City of **HOBART**

## APPLICATION UNDER HOBART INTERIM PLANNING SCHEME 2015

Type of Report:	Committee
Council:	23 April 2018
Expiry Date:	23 April 2018
Application No:	PLN-17-12
Address:	46 FEDERAL STREET , NORTH HOBART
Applicant:	JEFFREY ALLAN DAVIS 46 FEDERAL STREET
Proposal:	Alterations, Extension and Change of Use to Multiple Dwelling
Representations:	Five (5)
Performance criteria:	Inner Residential Zone Development Standards and Parking and Access Code

Figure 11: Original Proposed Elevations.

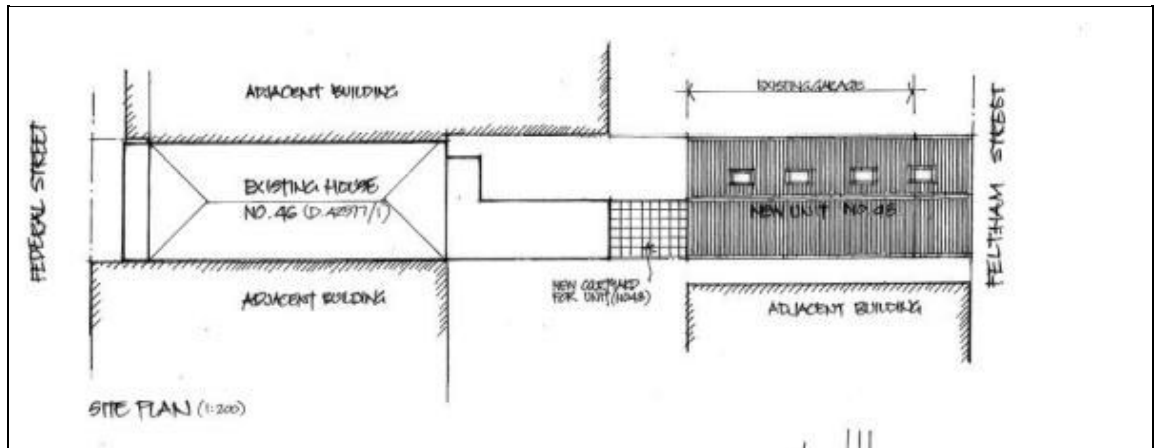
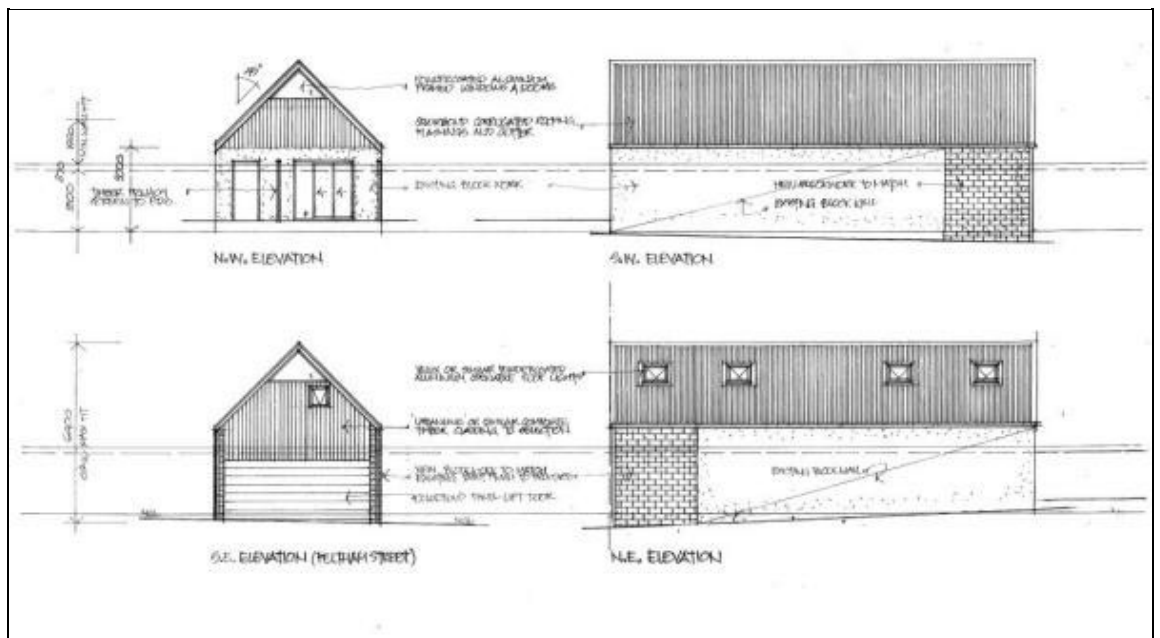
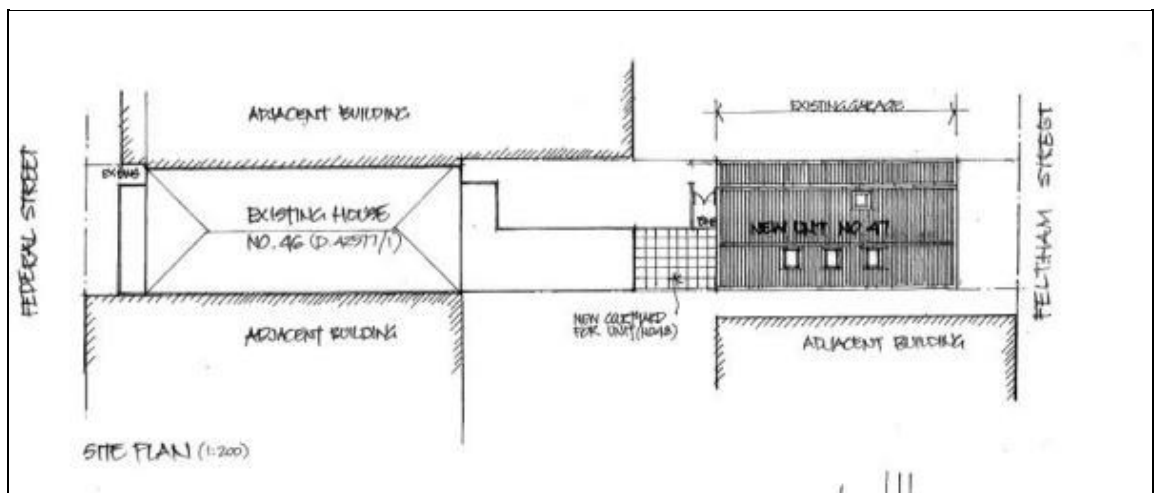
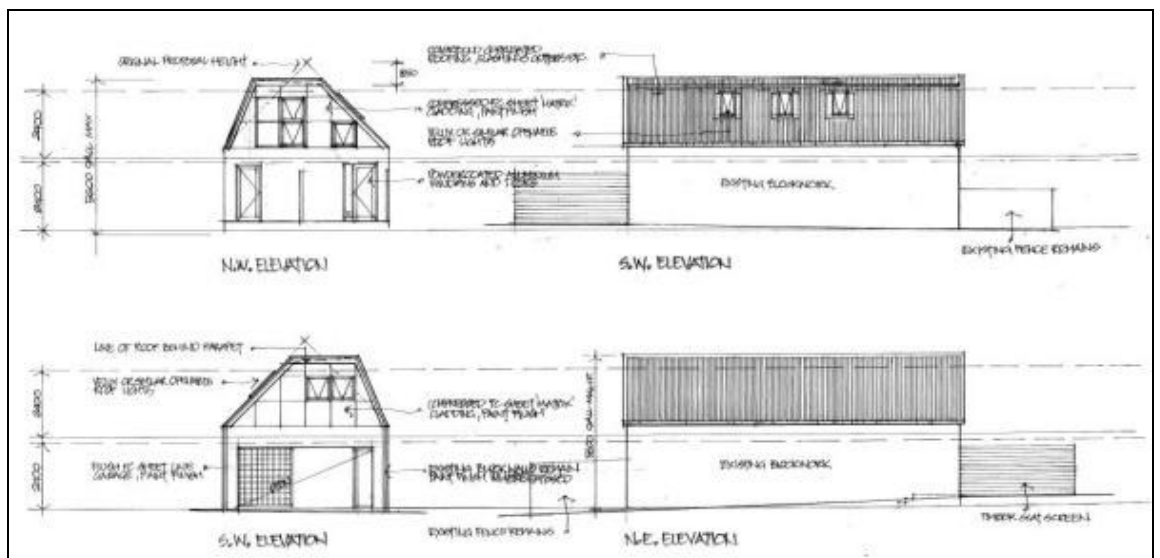
4.2 Council officers raised concerns with the applicant about the impact of the section of the proposed building extending towards the street on the sunlight into the window of the adjoining building at 51 Feltham Street (refer images 4 and 5 above). The applicant was informed that the original proposed design would not be supported by officers.

In response to officer concerns, the applicant submitted an amended design that proposed that the dwelling be contained within the existing footprint of the garage building. The existing garage walls would also be lowered from the 3.3m maximum height to 3m and the roof form altered to remove the peak of the gable allowing greater light penetration to the adjoining property beyond that of the permitted envelope. To allow for habitable space in the roof, the angle of the north eastern side was increased to 67.5 degrees. The amended design is shown below:

Figure 14: Amended roof angle offered by the applicant and to be required by condition.

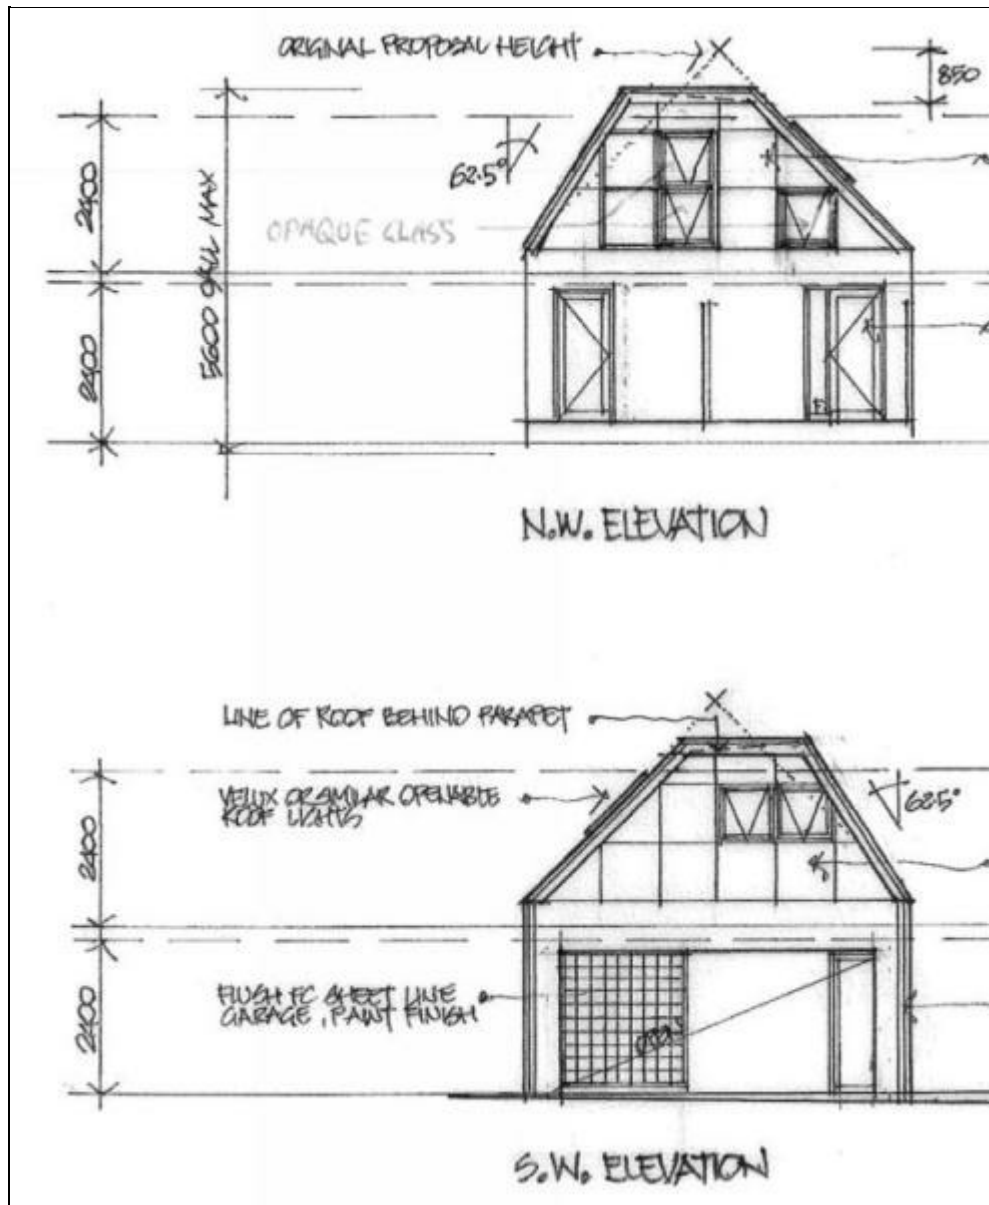
4.3 The amended design was re-advertised in October 2017 and received five (5) objections. The amended design is considered supportable in respect of the planning scheme requirements (refer to assessment below). In an effort to address additional concerns raised by representors, the applicant has offered further amendments to the proposal and provided the following statement:

- *The windows from the upstairs hallway and staircase on the NW elevation will be opaque so as to improve privacy for 48 Federal Street and the existing dwelling on 46 Federal Street.*
- *The proposed roof pitch has been lowered by 5 degrees to 62.5deg on the Northern side. The roof line remains at 850 mm under the maximum height as defined by the building envelope.*
- *The specification for the roof material has been changed to "Matte Colorbond" so that glare can be minimized for surrounding properties.*

The above additional amendments can be required by conditions on the permit. The proposed additional amendment to the roof angle is shown below.

**The angle of the north-eastern side of the proposed roof must be reduced 62.5 degrees.**

Figure 15: The red line is an indicative representation of the applicable permitted building envelope. Note that up to 3m on each side boundary,

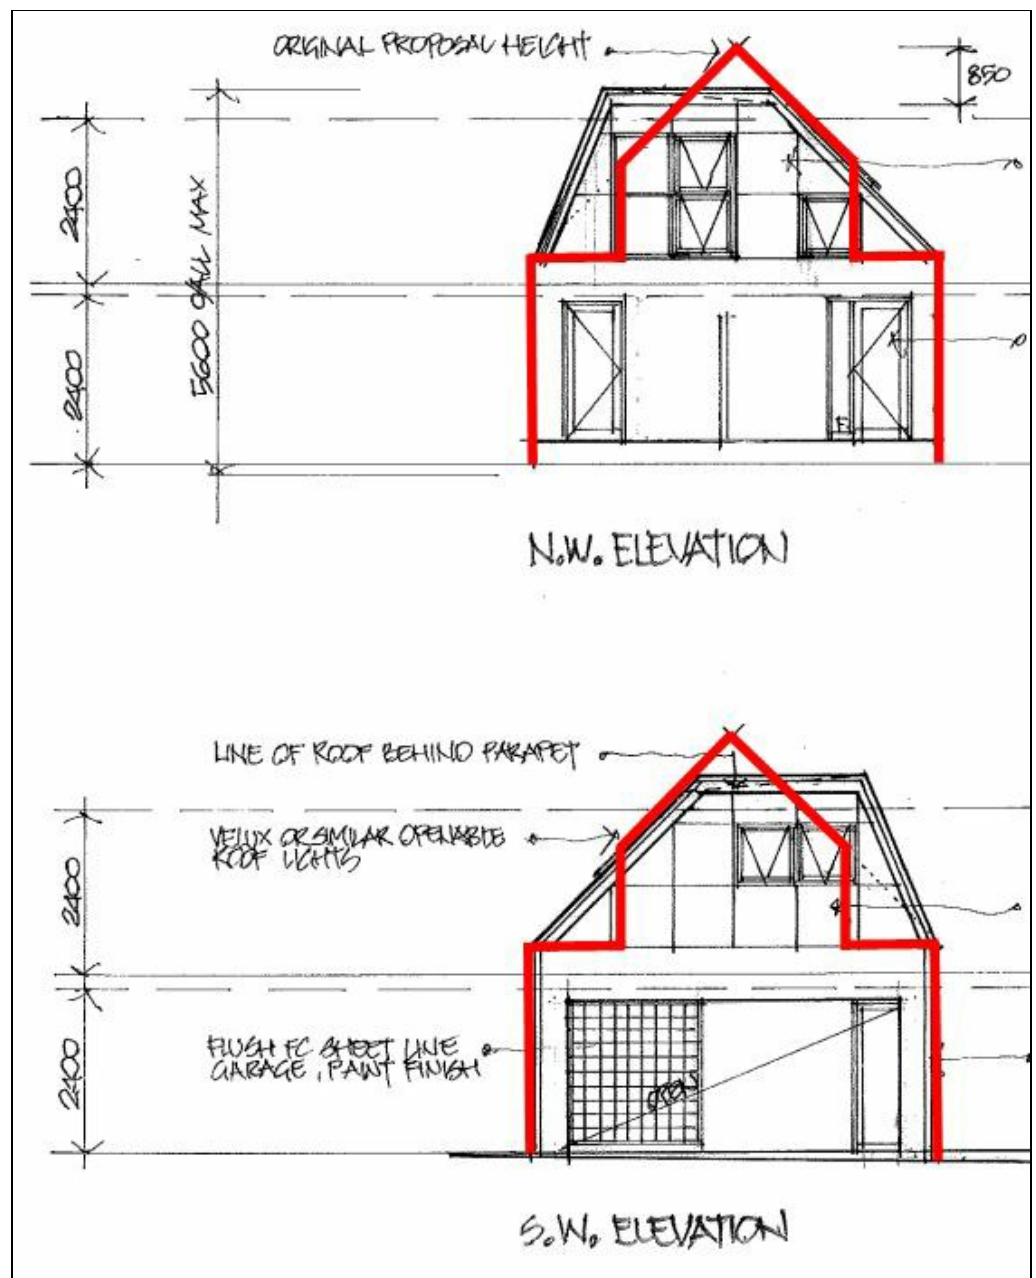
6.8.5 There are two aspects to the proposed building envelope discretion - the section of the proposed roof that is within 1.5m of the boundary and the part of the top section of the gable roof that exceeds the prescribed building envelope's 45 degree angle. The image below is indicative of how the prescribed building envelope and the 1.5m setback apply to the building:

Firstly, the triangle sections created by the 1.5m setback requirement have no tangible impact in terms of shadowing of the property to the south-west at 51 Feltham Street, as they are inset from the upper section of the roof, which is within the envelope. The removal of the gable peak (although within the permitted building envelope) and the lowering to 3m of the existing blockwork walls on the boundary will allow improved solar access. In terms of the visual impact created by these sections of the roof, the proposal will present an improved outcome due to the lowering of the blockwork wall on the boundary, which is currently at the same approximate height as the top of the windows, as seen in the image below:

Figure 17: Proposed reduced roof angle by applicant

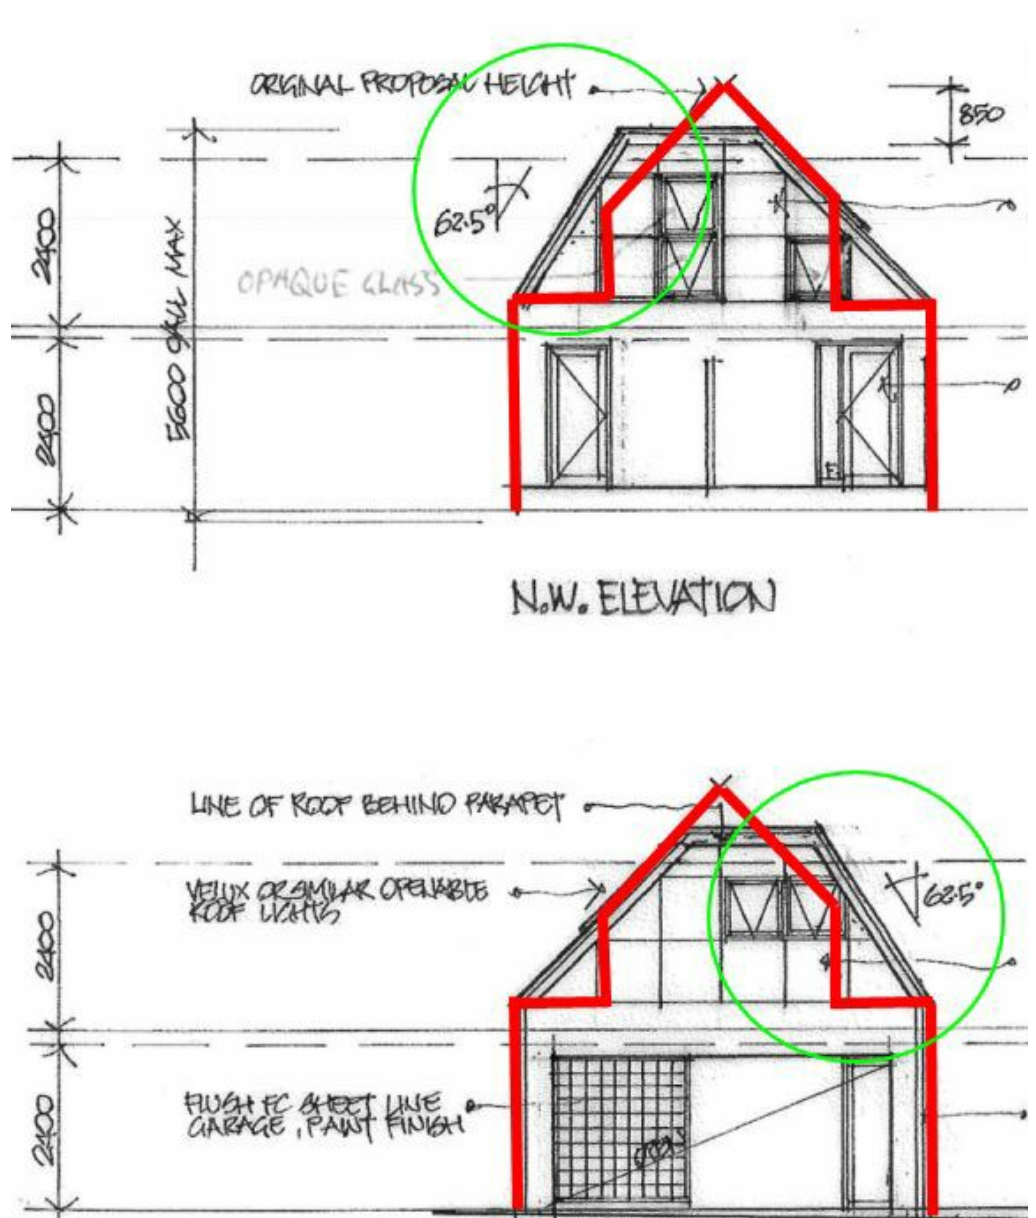
The proposed reduced roof angle leaves a very narrow sliver of roof outside the envelope and the 1.5m inset triangle sections as demonstrated in Figure 15 above. Irrespective of the encroachments, the majority of the adjoining property at 44 Federal Street is to the north and east of the subject site. Only the late afternoon sun to the rear of this neighbour will be affected, which is already affected by the existing garage wall, and in addition this impact is largely onto the neighbour's parking area. The minor variance of the angle of the roof from the permitted 45 degrees to 62.5 degrees (17.5 degrees) will only result in a brief additional impact to this area before the sun moves behind the

building. The encroachments are not considered to have an unreasonable impact in respect of overshadowing of the adjoining property.
